Technical Bulletin 215

03.2021

Description: Alarm Arm/Disarm Indicator Function - Instrument Software Update

Item: 215.2
Description: Triumph Shift Assist Accessory Kit A9770426
Model Affected: Trident (from VIN AC6898)

1. Alarm light

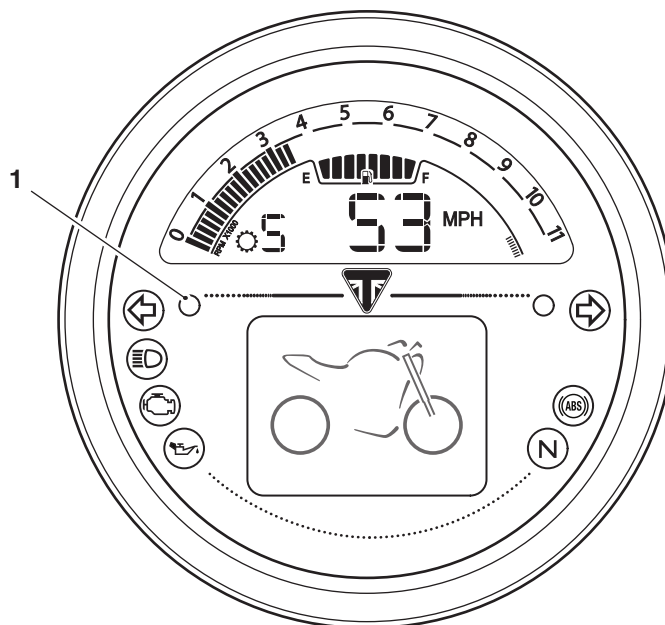
It has come to our attention that the above models that are fitted with an accessory alarm may have intermittent illumination of the direction indicators when the alarm is armed or disarmed. In some cases the only indication of the alarm being set is the red LED light on the instruments which will illuminate for 2-3 seconds after arming. The alarm operation is not affected and no action is needed if no alarm is fitted.

An instrument calibration update will be available from 15th March 2021 in Triumph diagnostic tool version 2021-05 to resolve this issue. Dealers are requested to use **Manual Model Selection** to download instrument calibration **INST00162_ROW_CM** to affected models at the next service/visit to the dealership.

Check the instrument build data screen. The Triumph Boot Software part number and issue level should be reported as follows after updating via **Manual Model Selection**:

- Boot Software Part Number - 02570841
- Boot Software Issue Level - 020000

1. Gear change pedal
2. Press
3. Press bars

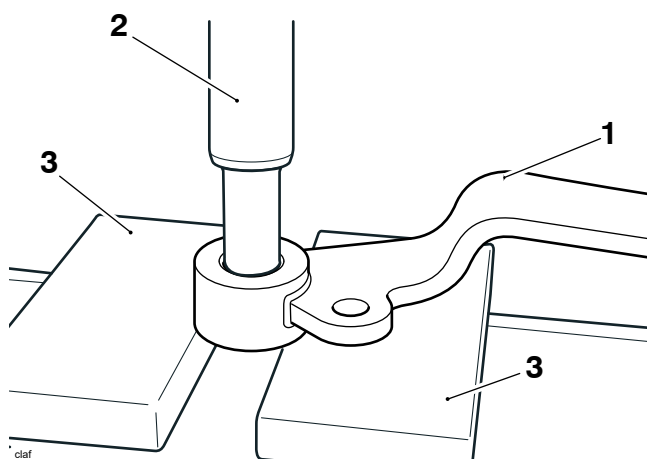
Press only on the bush outer edge to prevent damage to the bush and the gear change pedal.

- Note the position of the bush in the gear change pedal for installation.

1. Support the original gear change pedal on the press bars.
2. Press on the bush outer edge to remove it from the original gear change pedal.

3. Check the gear change pedal for damage. If damaged a new bush must be fitted.

- 1. Gear change pedal
- 2. Press
- 3. Press bars

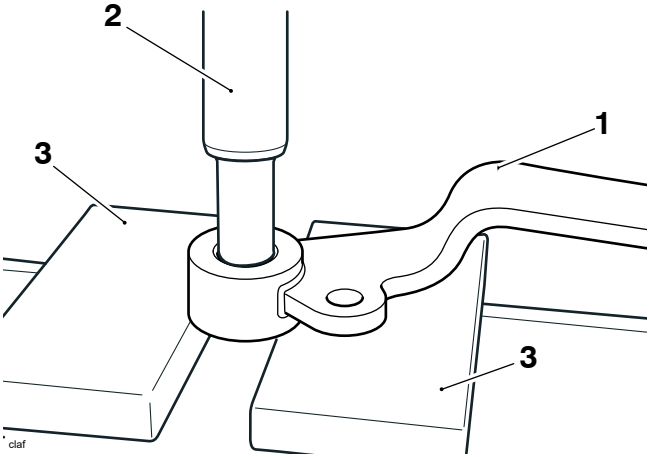
- 1. Support the new gear change pedal on the press bars.
- 2. Press on the bush outer edge to install the bush in to the new gear change pedal to the depth noted for removal.
